SITE PLAN REVIEW AND APPEARANCE BOARD

Meeting: October 16, 2019 | File No: 2019-147-SPF-SPR-CLV | Application Name: OSC Townhomes – 202 SE 4th Avenue

SITE PLAN

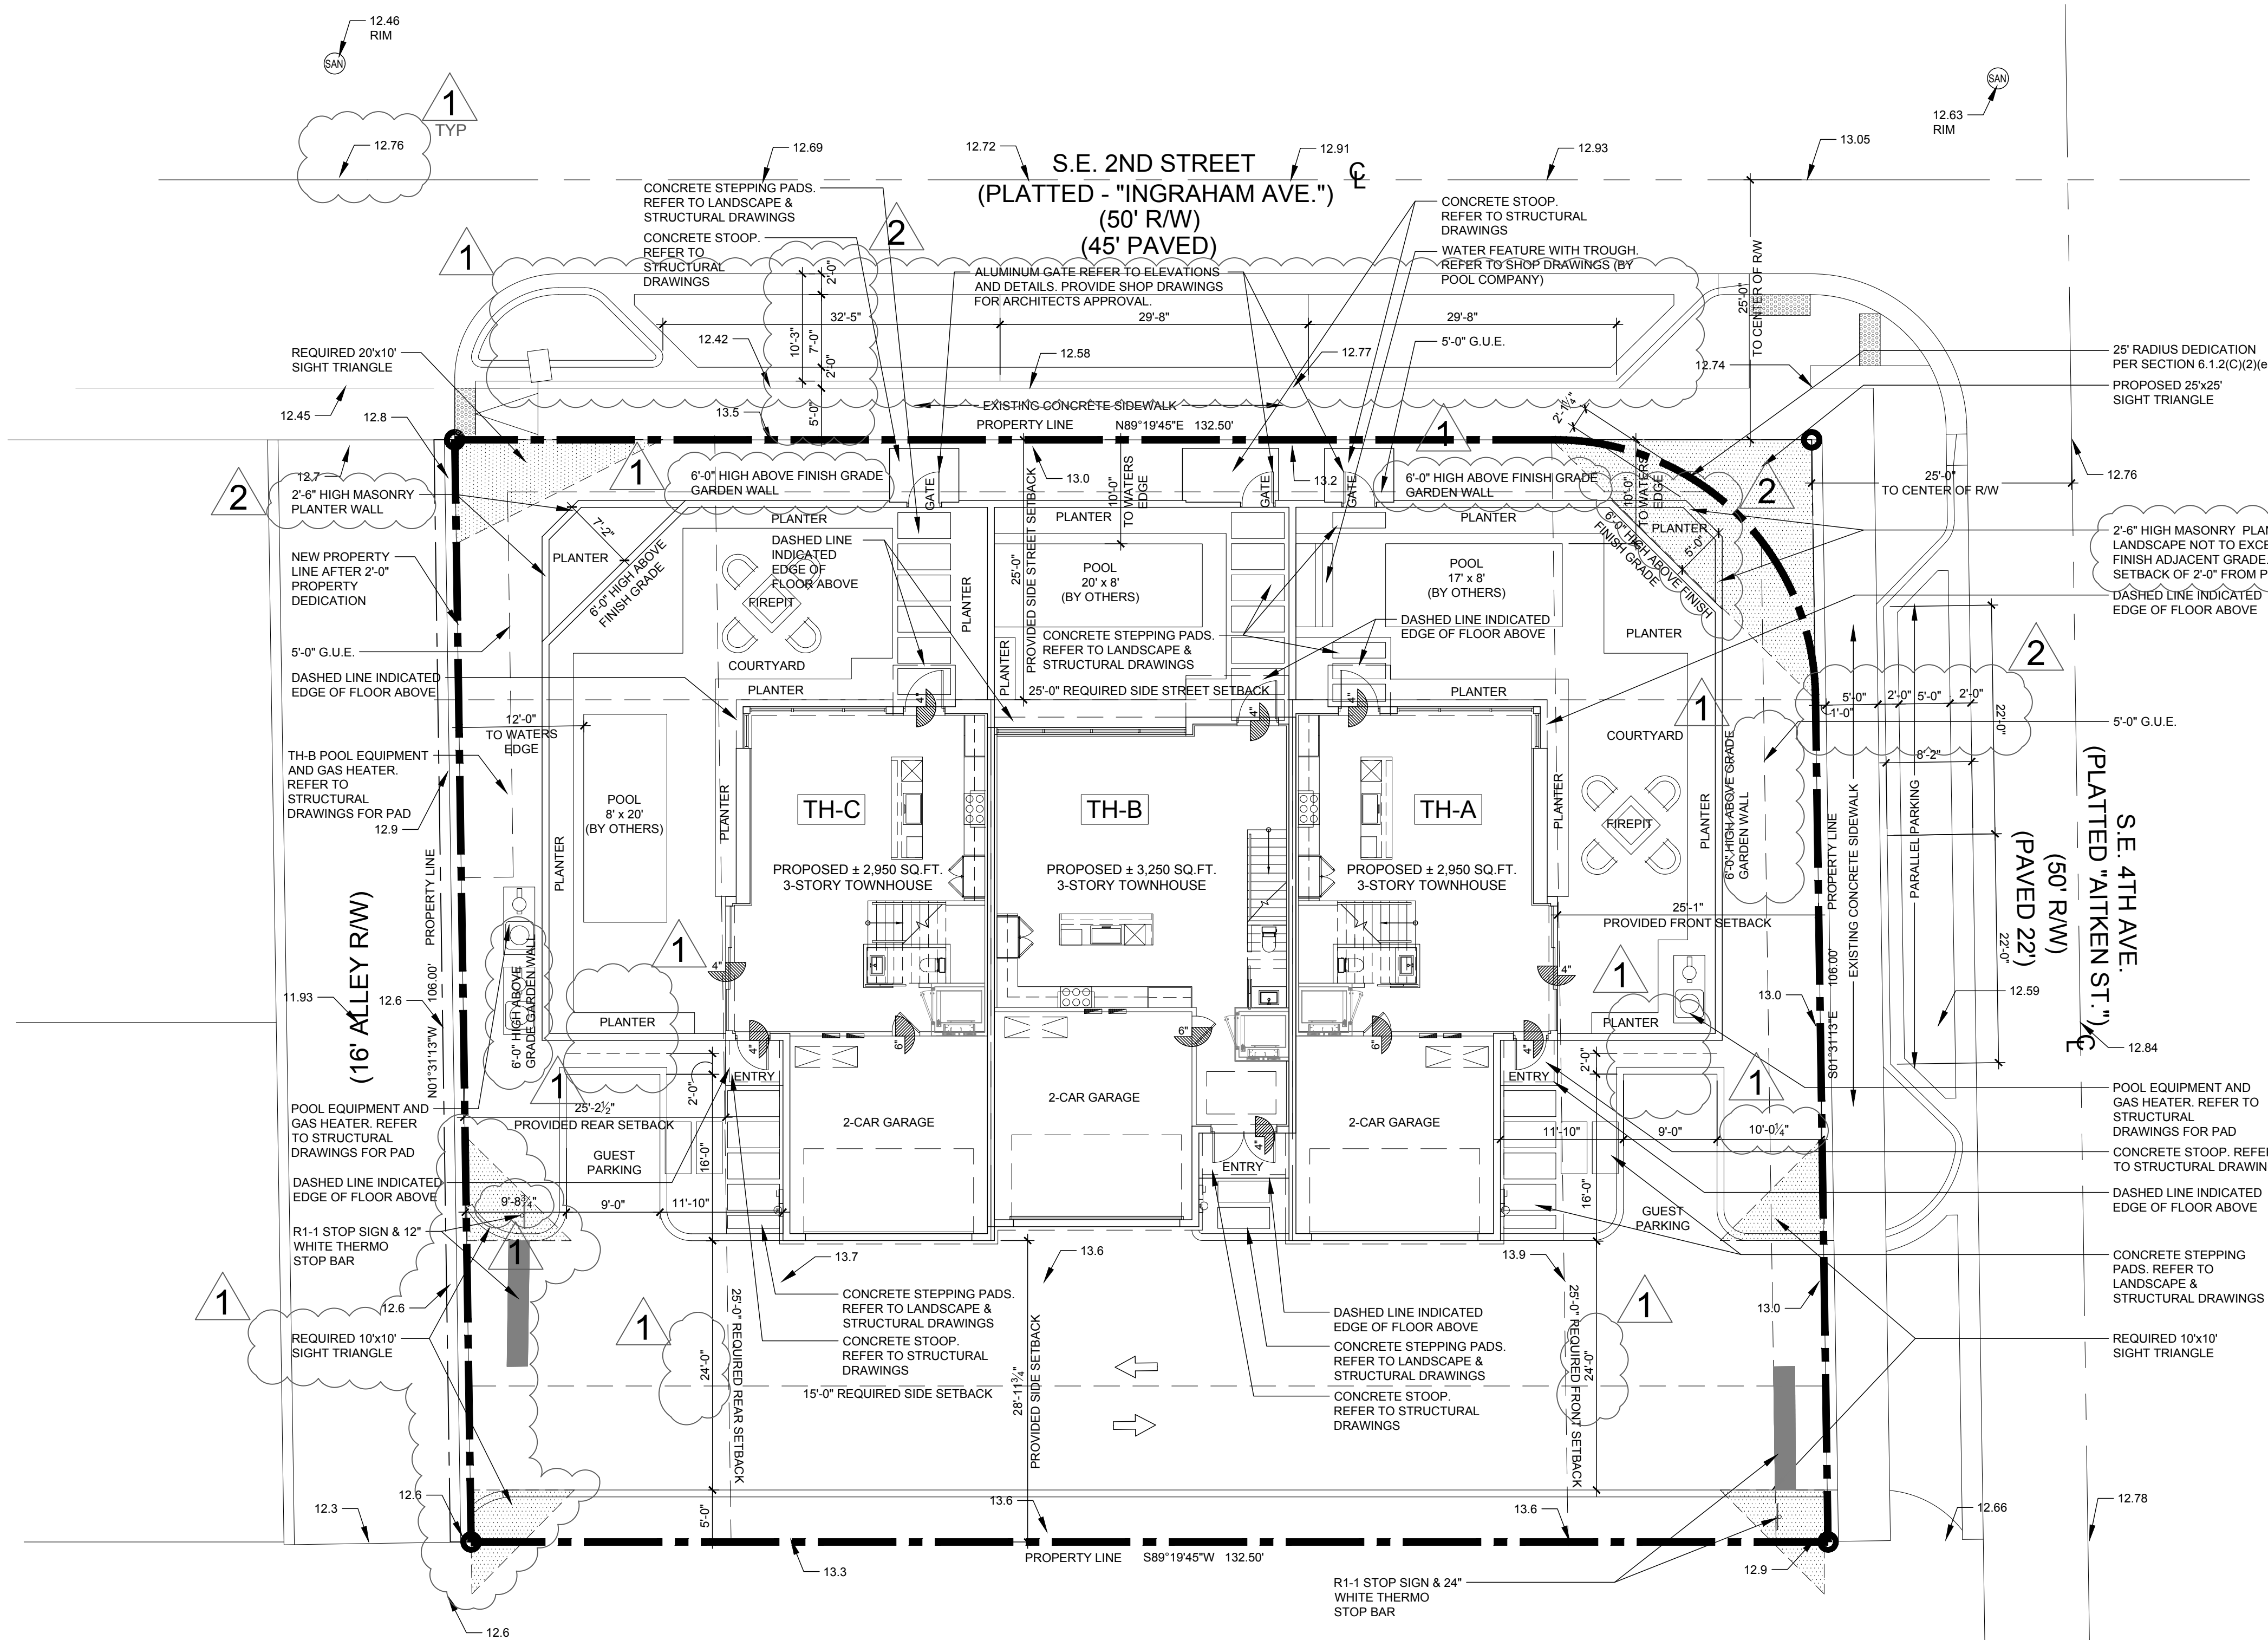
- As shown on page SP-1, the townhomes facing SE 2nd Street have a 2-car garage with a setback of at least 25', thus complying with this requirement.

- Site plan SP-1, shows a 6' high masonry screen wall adjacent to the front yard, side street, and rear yard setbacks. The wall is offset approximately 6' from the property line to allow for landscaping to grow in the front of the walls. Furthermore, the north property line contains two triangular landscape planter beds contained in a 3' tall masonry planter. As shown on page L-2, the proposed Fakahatchee Grass plants shown to screen the concrete walls are identified to be installed at 24" in height at time of planting. The plant material selected in accordance with LDR Section 4.6.5 (E), will grow to a mature height within two years, to be maintained at a height half the size of the wall. The proposed wall and hedge heights comply with the aforementioned LDR section.

- Site Plan page SP-1 shows a 9.8' stacking distance on the west side of the property from the alleyway to the first parking guest parking space, and a 10.3' stacking distance on the east side of the property from SE 4th Avenue (local road) to the first parking spaces. The proposed stacking distances exceed the minimum requirement listed above.

- As shown on page SP-1, the existing alleyway is shown to be 16'. As such, the plans show the development is providing a 2' dedication along the alleyway to contribute to the required 20' ROW minimum requirement for alleys in accordance with 5.3.1(D)(2) Table T-1.

**planting
plan**

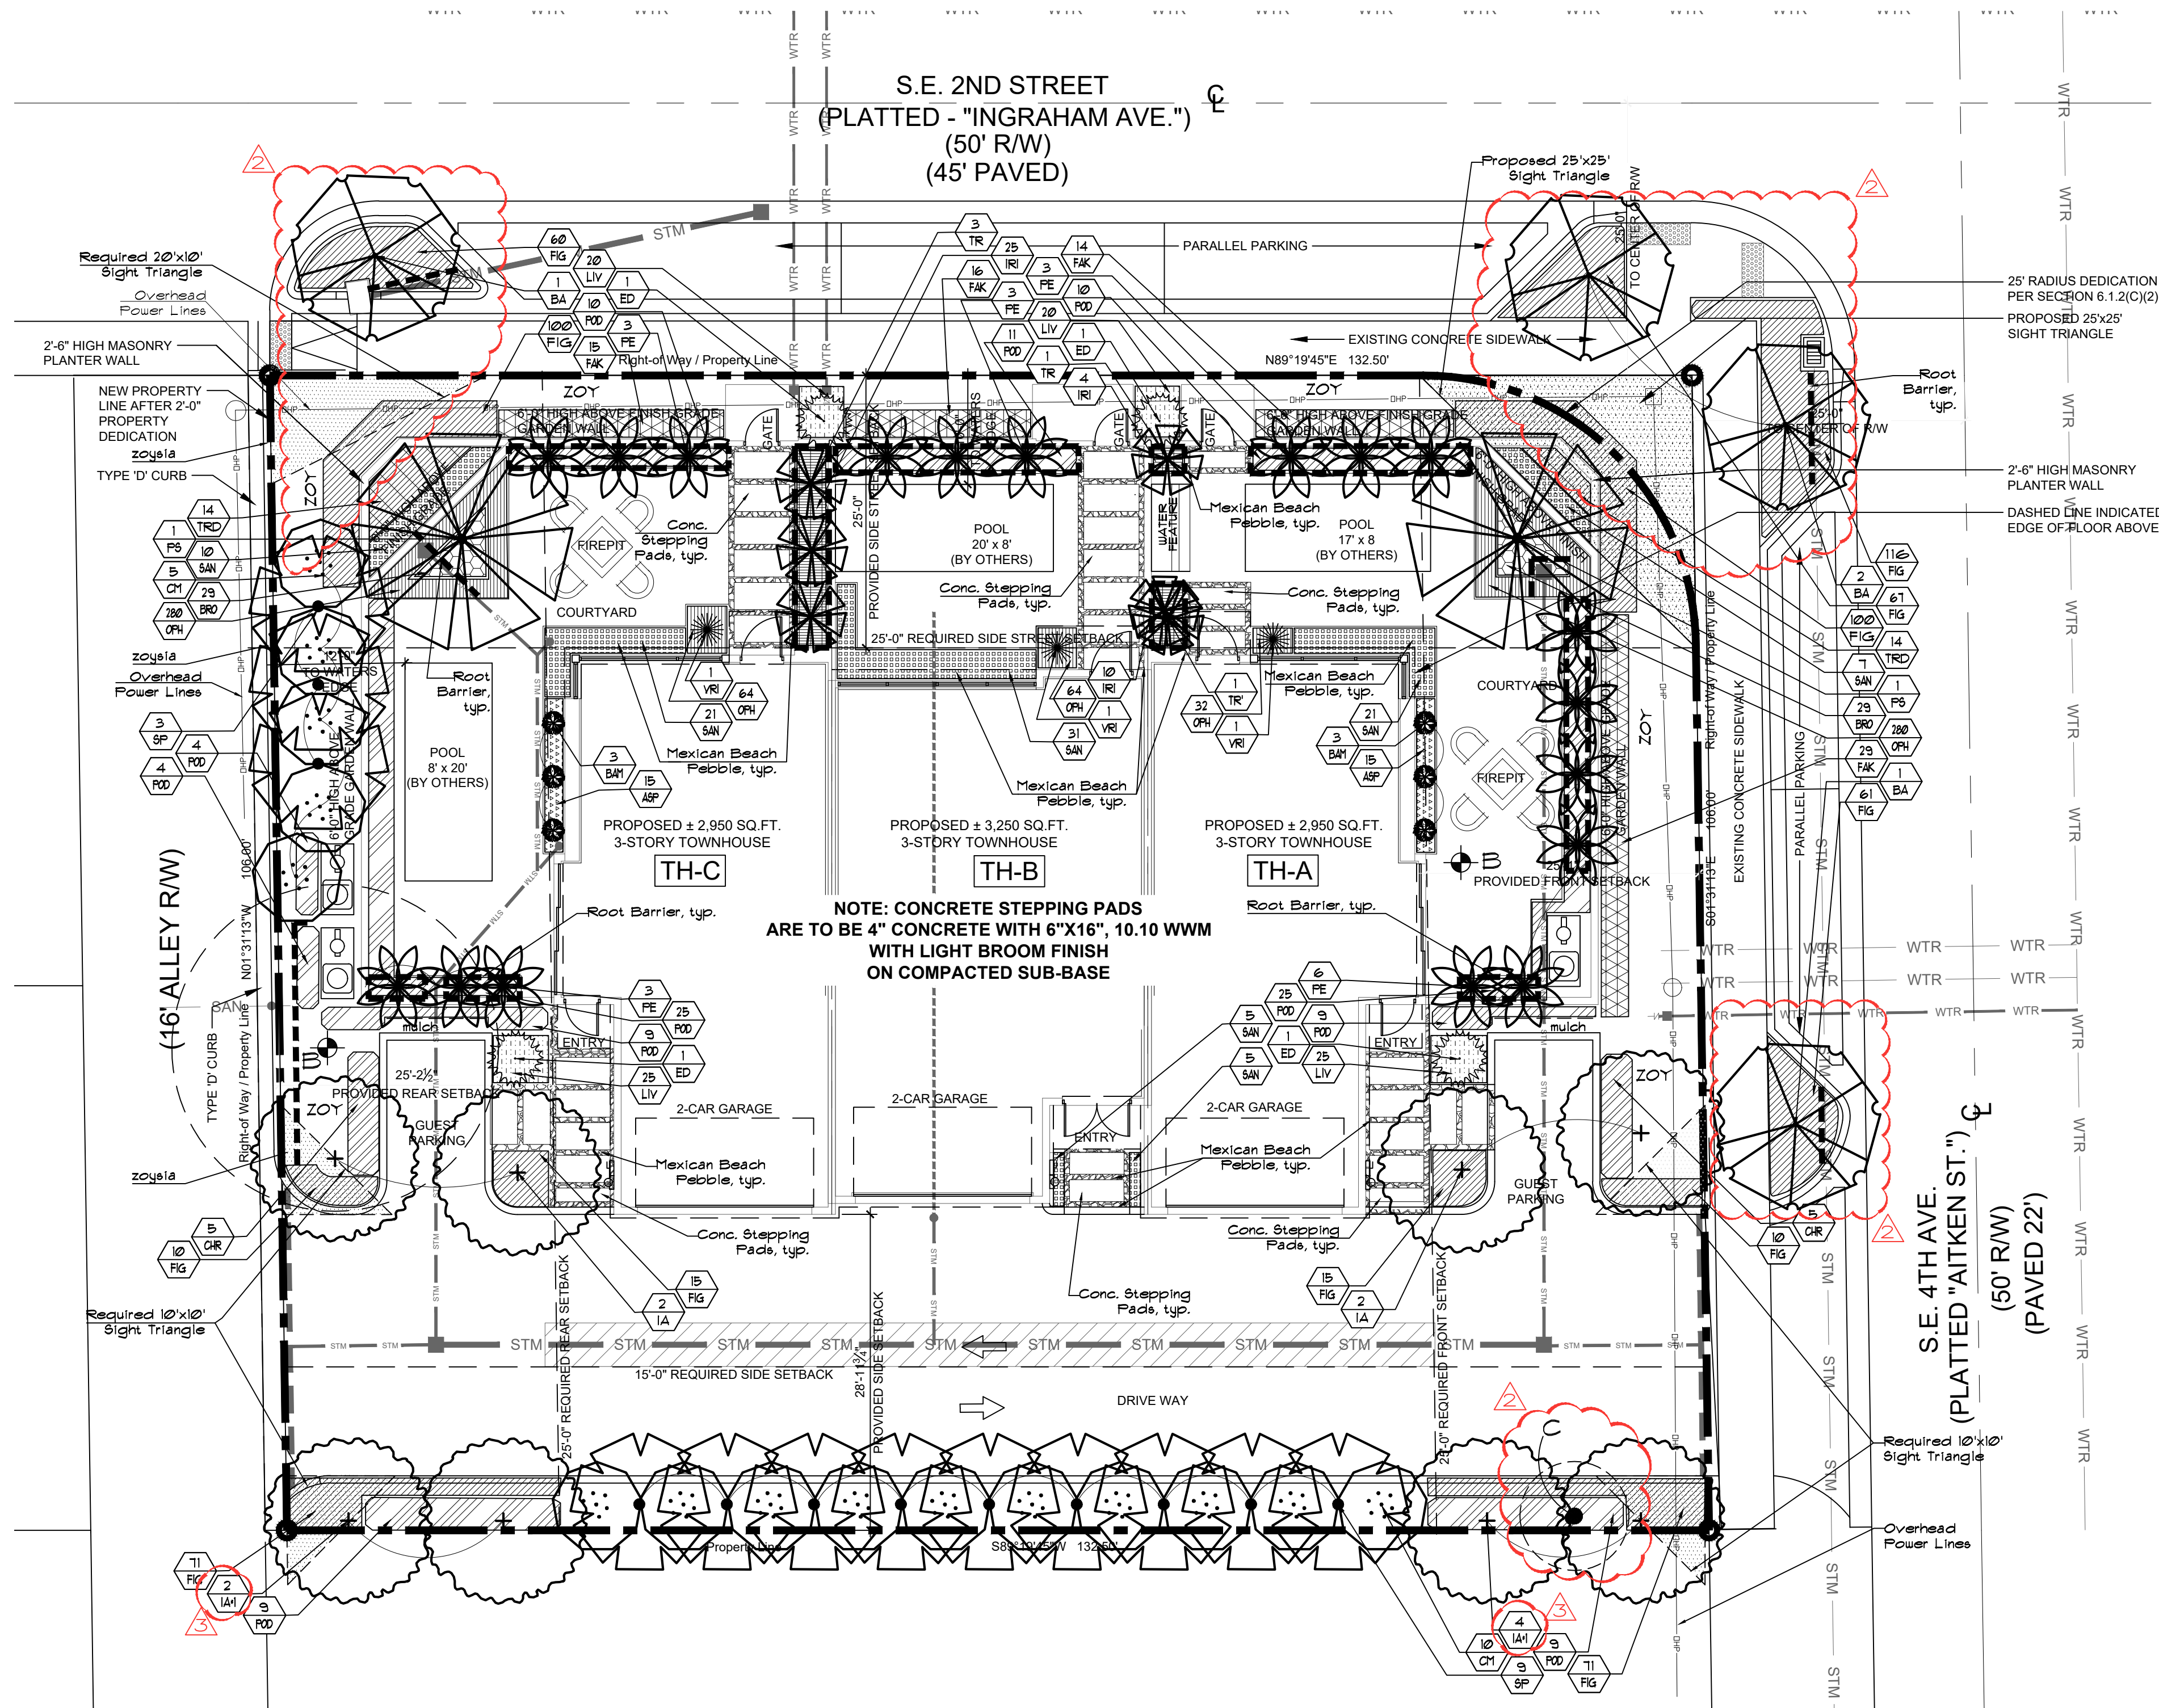
Specifically, plan page L-2 shows a row of 13 trees adjacent to the south property line placed 8' to 14' feet on center to create a dense continuous buffer of trees. The trees provided will be made up of canopy trees and palm trees. The Holly trees are specified at a height of 20', Fishtail Palm are specified

at 16' in height, and the Sable Palms are specified at a height of 26'. The Sable Palms and the Holly trees specified are over 25% larger in height than what is specified in the code as required in this LDR section.

one Cabbage Palm tree. Furthermore, the plan shows the removal of two Seagrape trees and one Green Buttonwood tree. Plan page L-2 shows a lush variety of native and Florida Friendly landscape material proposed for the development. The quantity and size comply with the minimum requirement listed in the LDR. The landscaping selected along SE 2nd Street and SE 4th Avenue are composed of a row of Solitaire Palm trees with ornamental grasses and foundation plant material. The two corners of the property adjacent to SE 2nd Street feature raised triangle planter beds in front with Sylvester Date palms, which aesthetically frame from the front of the buildings. Along the west property line, a row of Sable palm trees with foundation plants and ornamental grasses buffer the property from the adjacent alleyway. As previously mentioned, adjacent to the south property line features a row of East Palatka Holly trees spaced 15' on center, Sable Palms spaced 8' on center and a continuous row of shrubs. Additionally, the landscape material provided along the south property line provides a buffer from the higher density use of the subject property to the lower density Single-Family zoned properties to the south.
